Subject ▶ Change on casing complete, plate, knob 40, etc.

For Models ▶ 6830 (Auto Feed Screwdriver), 6831DH, 6831DWH (Cordless Auto Feed Screwdriver)

▶ Current	▶ New

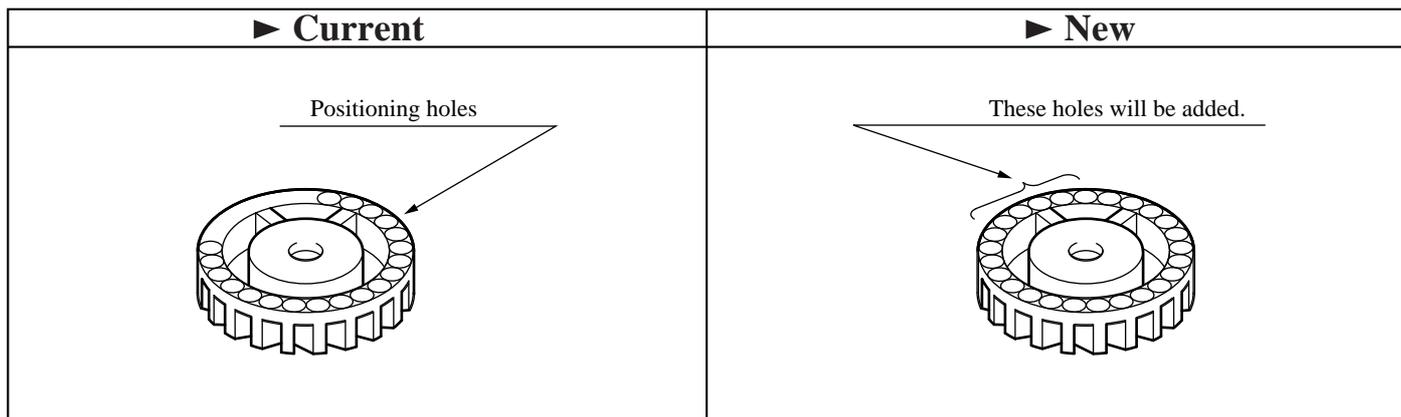
1. The plate will be changed in shape.
